BAY AREA TOLL AUTHORITY
BAY AREA METRO CENTER
375 BEALE STREET
SAN FRANCISCO, CA 94105

Addendum No. 1
to
INVITATION FOR BID
FOR THE RICHMOND-SAN RAFAEL BRIDGE ACCESS IMPROVEMENT PROJECT
Dated August 23, 2016

This letter is Addendum No. 1 to the Invitation for Bid for the Richmond-San Rafael Bridge Access Improvement Project dated August 23, 2016. Where text is revised, deleted text is shown in strike-through format; added text is ***italicized***. The IFB is revised as follows:

DEVELOPED ELEVATION

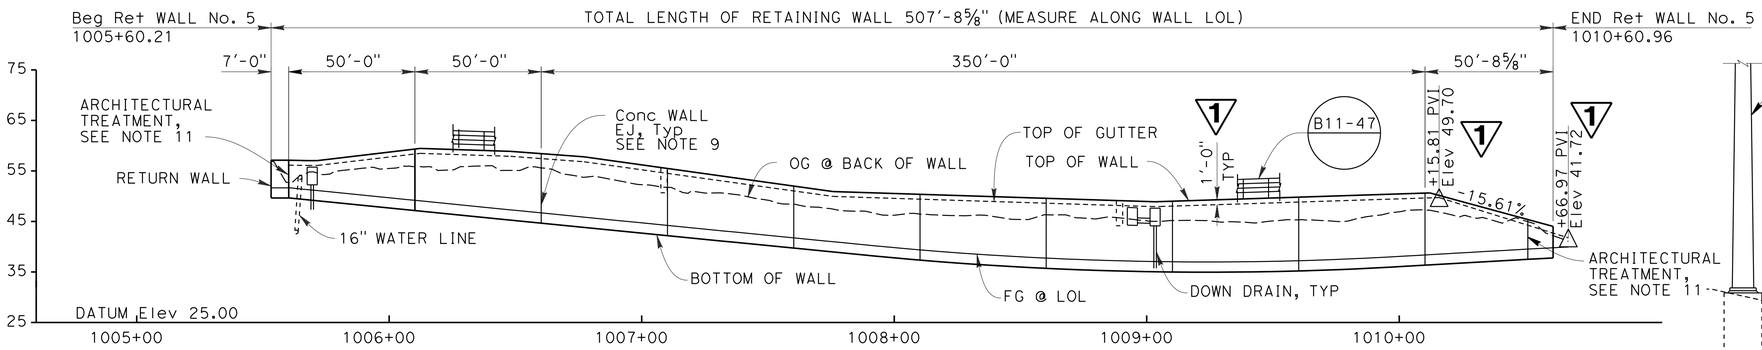
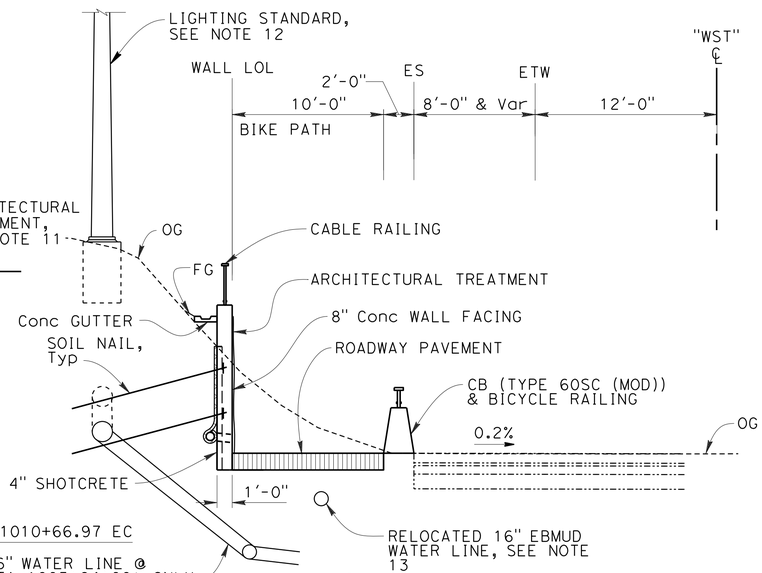
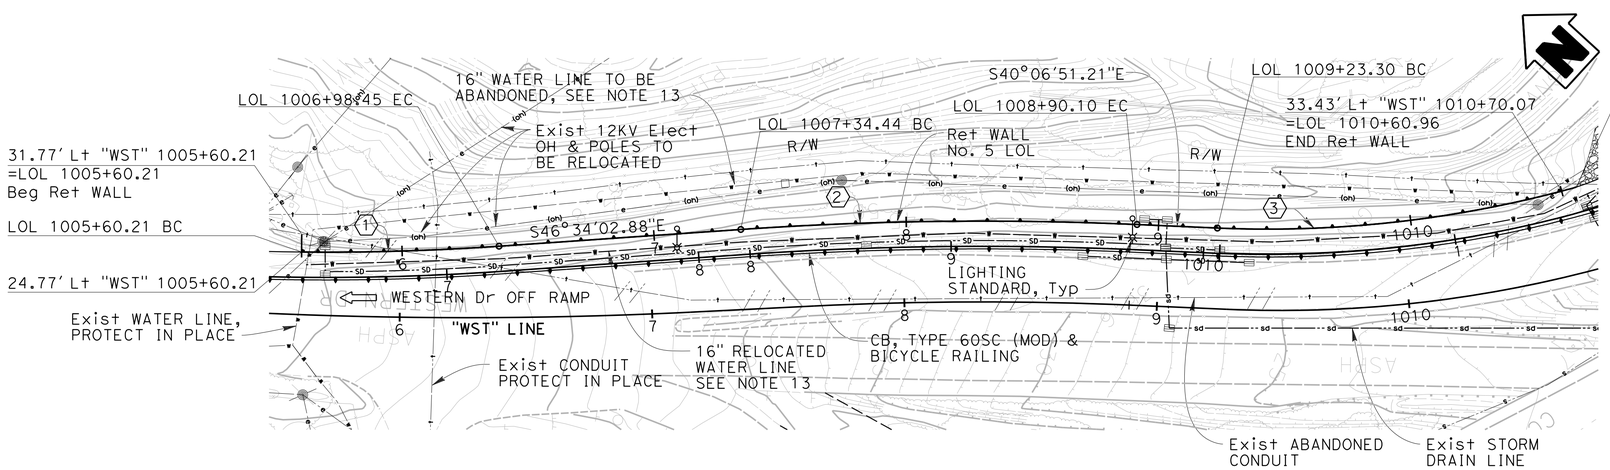
STRUCTURE EXCAVATION (SOIL NAIL WALL)	~~168~~ 327	CY
STRUCTURE BACKFILL (SOIL NAIL WALL)	75	CY
STRUCTURAL SHOTCRETE	59	CY
STRUCTURAL CONCRETE (RETAINING WALL)	189	CY
BAR REINFORCING STEEL (RETAINING WALL)	25,415	LB
MINOR CONCRETE (GUTTER)	502	LF
~~GEOCOMPOSITE DRAIN~~	~~641~~	~~SQFT~~
CABLE RAILING	509	LF
SOIL NAIL	2,929	LF
ARCHITECTURAL TREATMENT	6,686	SQFT
